3 H.P. PLUNGE ROUTER (With Brake) Model 3612(MCA)

SERVICE CHANGES

(MCA Products only)

1. Change on Motor Bracket Com. and Bearing Retainer.

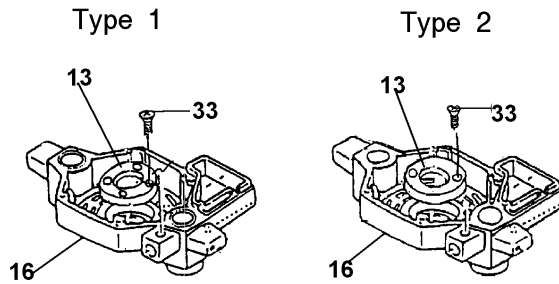
Item No.	Description	Type 1	Type 2
13	Bearing Retainer 50	285657-0	
		4 Holes	2 Holes
33	(+) C.S.H. Screw M4x14	251295-0	
		4 pieces	2 pieces
	Serial No.	N/A	N/A

2. Change on Knob, Compression Spring 12, Nut & Flat Washer.

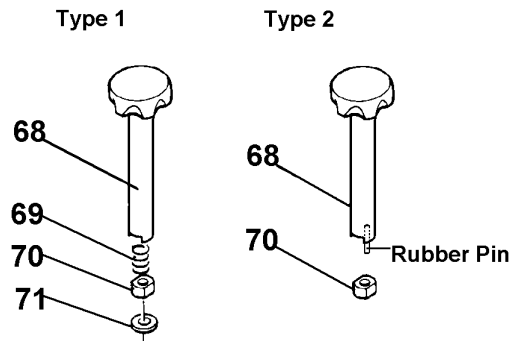
Item No.	Description	Type 1	Type 2
68	Knob 50/Knob 50 Com.	271299-6 (No Longer Available)	152566-7 With Rubber Pin 4 (263002-9)
69	Compression Spring 12	231231-2	-----
70	Nut	252203-4 M10-15	410129-8 M10
71	Flat Washer 10	941251-5	-----

Above parts are completely interchangeable as a set.
